MOUNTAIN AVENUE CORRIDOR COMPLETE STREETS IMPROVEMENTS PROJECT 30% UPDATE – STUDY SESSION

ALTERNATIVE CROSS SECTION (a)
HURON PL TO BUTTE ST/8TH ST

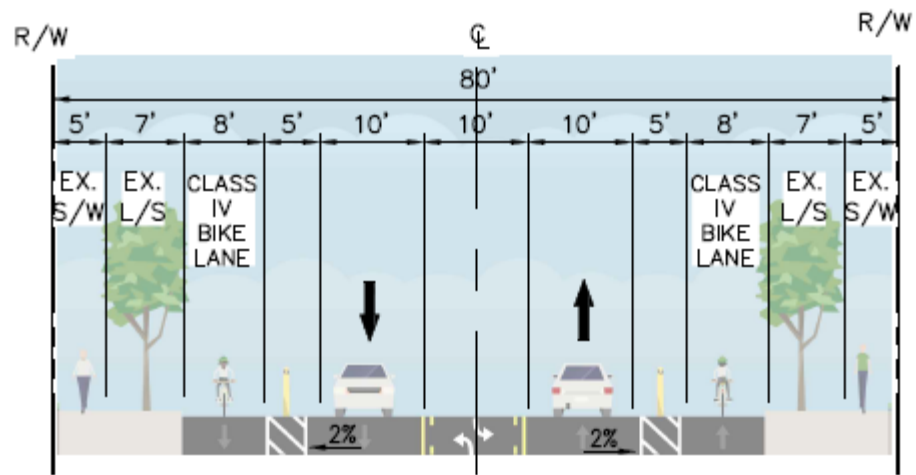
NOT RECOMMENDED DUE TO THE FOLLOWING:

- REDUCES PARKING WIDTH WHILE NOT SIGNIFICANTLY INCREASING BIKE LANE
- INCREASES POSSIBILITY OF VEHICLE ENCROACHMENT INTO BIKE LANE
*AVERAGE VEHICLE WIDTH = 6.5'; PARKED VEHICLES MAY ENCROACH IN BIKE LANE IF PARKED 1.5' (MAX. ALLOWABLE DISTANCE PER CLAREMONT POLICE DEPARTMENT FOR PARKED VEHICLES) FROM EDGE OF CURB

ALTERNATIVE CROSS SECTION (b)
HURON PL TO BUTTE ST/8TH ST

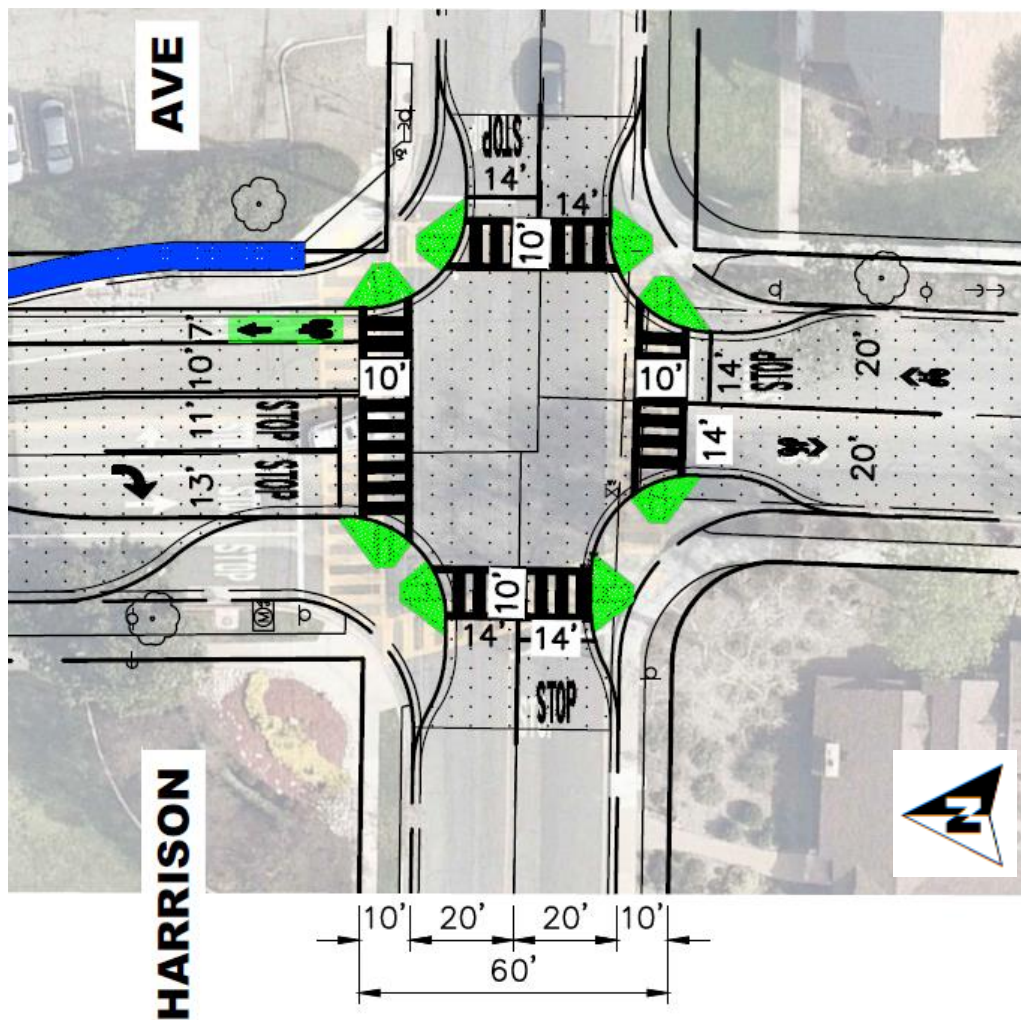
NOT RECOMMENDED DUE TO THE FOLLOWING:

- REMOVES ON-STREET PARKING FOR RESIDENTS ALONG MOUNTAIN AVE
- LARGE QUANTITY AND CLOSELY SPACED DRIVEWAYS WILL CAUSE BREAKS AND DIFFICULTIES WITH MEDIAN/BUFFER (E.G. ISOLATED ISLANDS AND INCONSISTENT/UNPREDICTABLE STRIPING PATTERNS)

ALTERNATIVE CROSS SECTION (a)

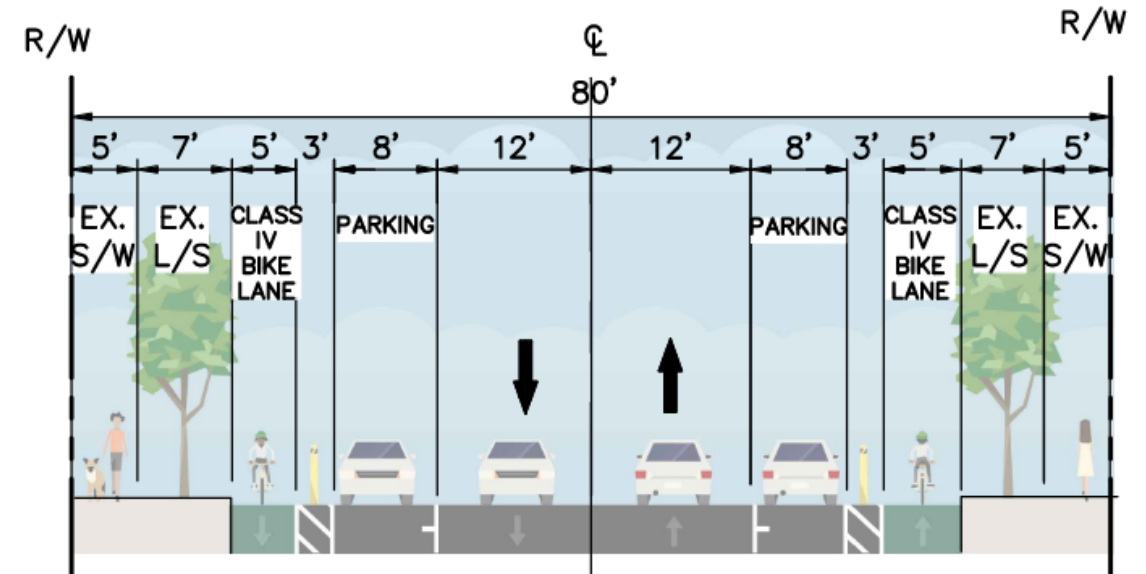
- Impedes First Responder ability to respond
- ADA access is impacted
- Trash Pickup is impeded
